Groundwater Flow and Solute Transport Modelling to Evaluate Disposal
of Beaver Dam Tailings in Touquoy Open Pit - Beaver Dam Gold Project -

Completed for the Updated 2021 Beaver Dam Mine EIS

**Groundwater Flow and Solute
Transport Modelling to Evaluate
Disposal of Tailings in Touquoy
Open Pit**

Response to Regulator Comments Regarding Groundwater Modelling Update to Address November 5, 2020 Information Request from IAAC for the Beaver Dam and Fifteen Mile Stream Projects.

Study Area and Model Grid

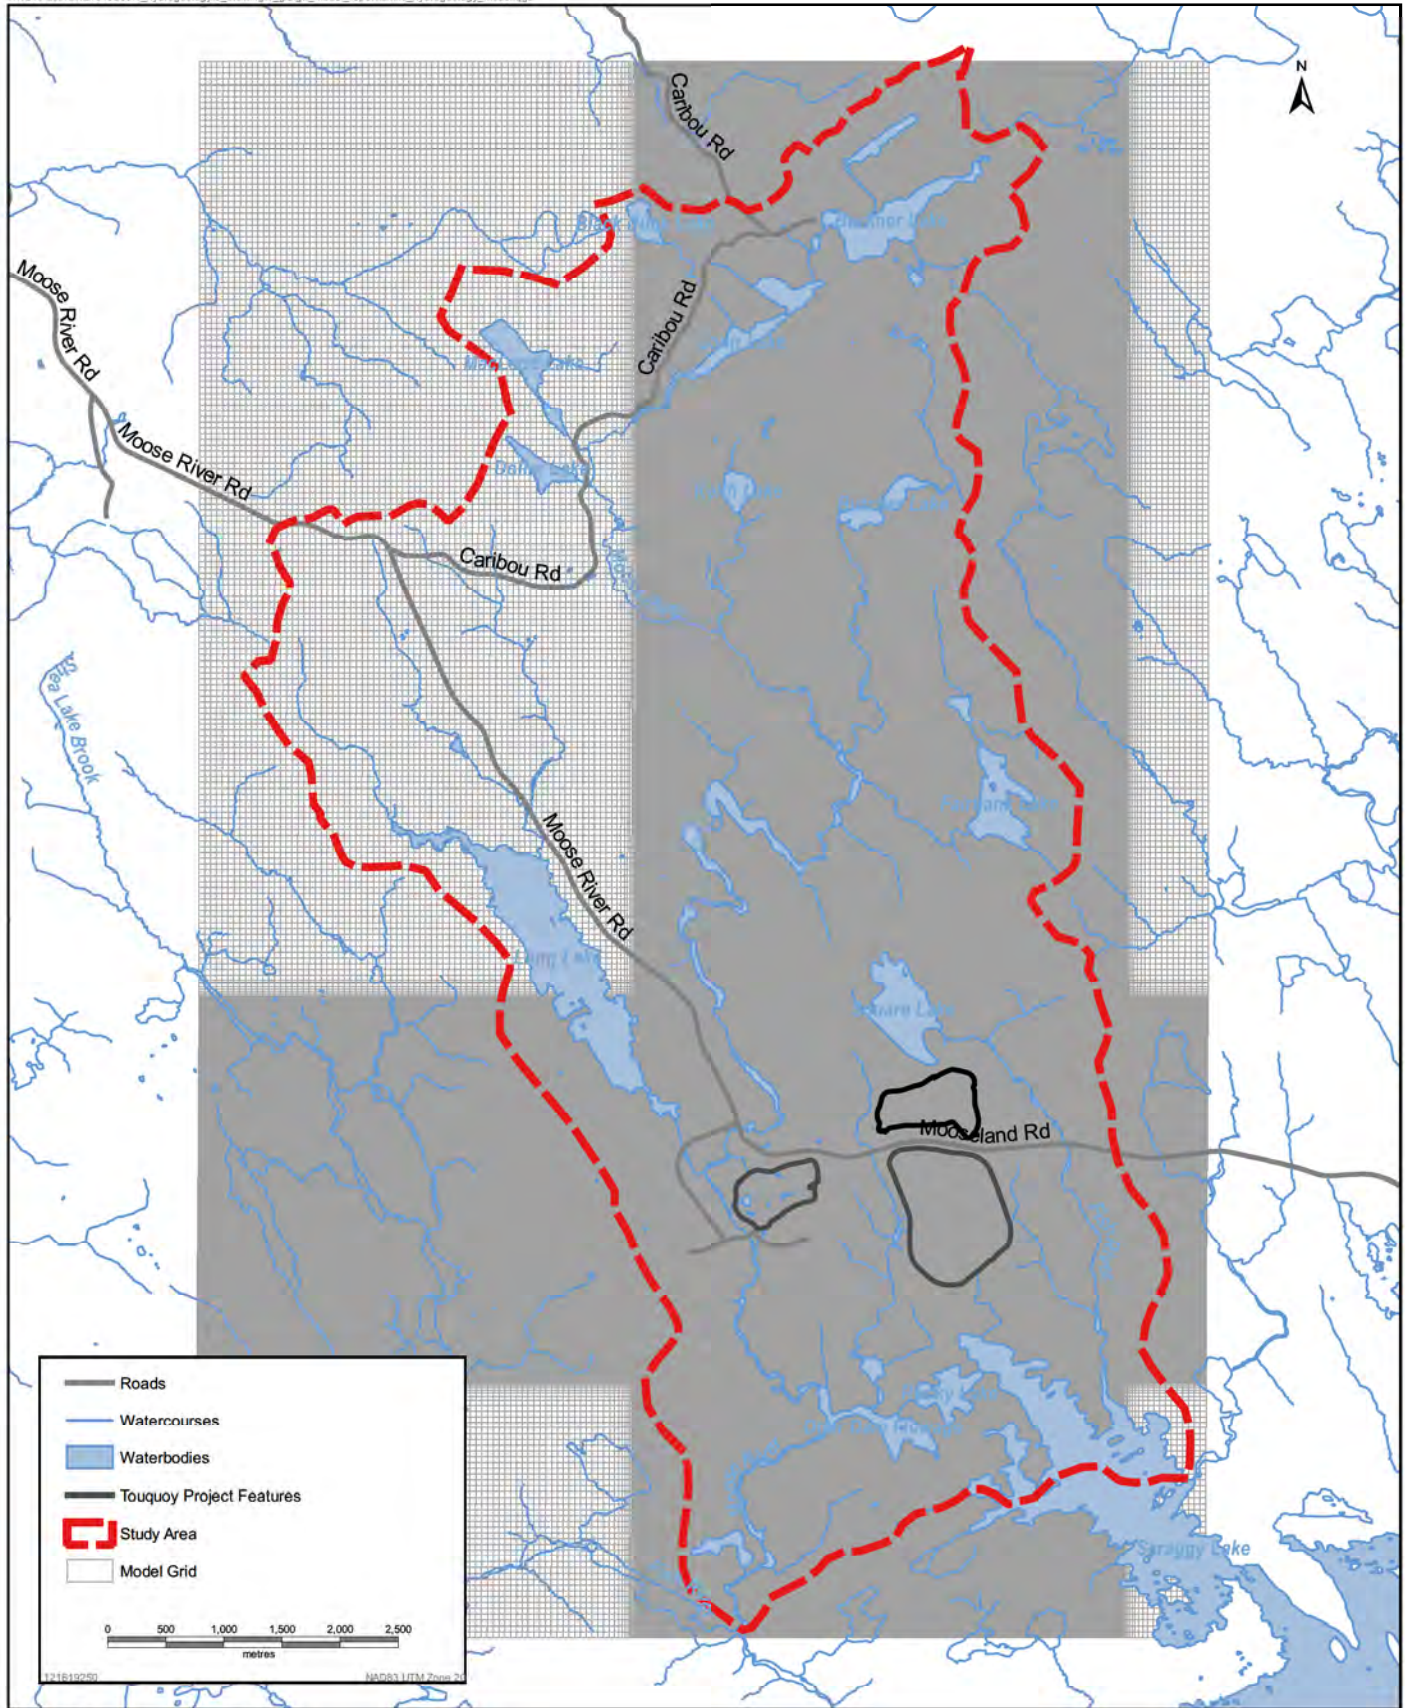
Item	Comment	Response
Nova Scotia Environment (Email from Bridget Tutty 9/12/2020)		
NSE-1	Provide representation in the document of the new model discretization. Include a figure showing the overall site modelling grid and domain.	See Section 4.1
NSE-2	Provide information and a cross-section figure from the Moose River to the open pit which shows the hydrogeological conceptual model (including details of actual stratigraphy) for groundwater interactions as well as the model layers and parameters that are representative of this.	See Section 4.1
NSE-3	Update the revised model groundwater calibration analysis based on changes to the model grid, include stream baseflow target for both average annual and yearly minimum flow conditions.	See Section 4.4.3
NSE-4	Update the uncertainty/sensitivity analysis to include the variable effects of streambed conductivity on observed streamflows and groundwater influx to the open pit.	See Section 4.4.6

The model grid was constructed to cover the Study Area, as shown on Figure 4.1. The grid is composed of 624 rows and 562 columns for a total area of 117.6 square kilometres (km²). Cells outside the Study Area are designated “inactive.” The total active area of the model is approximately 58.2 km².
